CITY OF TORRANCE, CALIFORNIA

ADDENDUM NO. 2
Issued: July 9, 2010

**PROPOSAL, SPECIFICATIONS, BOND AND
AFFIDAVIT FOR THE CONSTRUCTION
OF
DEL AMO BOULEVARD EXTENSION, T-30
FEDERAL PROJECT NO. ESPLRSTP 5249-(021)
B2010-12**

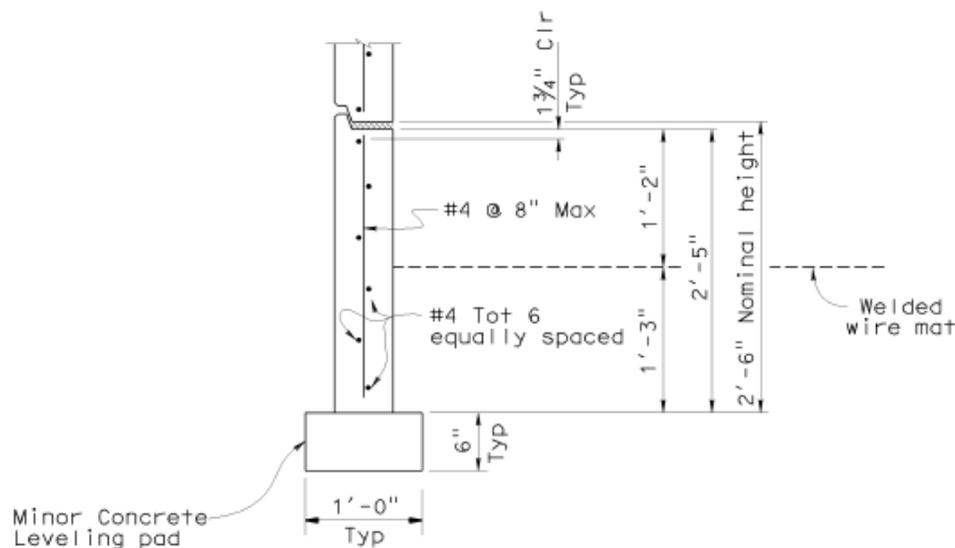
9. Refer to the Special Provisions **MECHANICALLY STABILIZED EARTH WALLS, SECTION 300, Subsection 300-13.6.2 Concrete.**

Please add the following to the last paragraph:

“The minor concrete leveling pads shall also conform to Caltrans Detail No. 1 for Mechanically Stabilized Embankment XS Sheet Number xs-13-020-1e.”

The Detail is shown below and can be downloaded from:
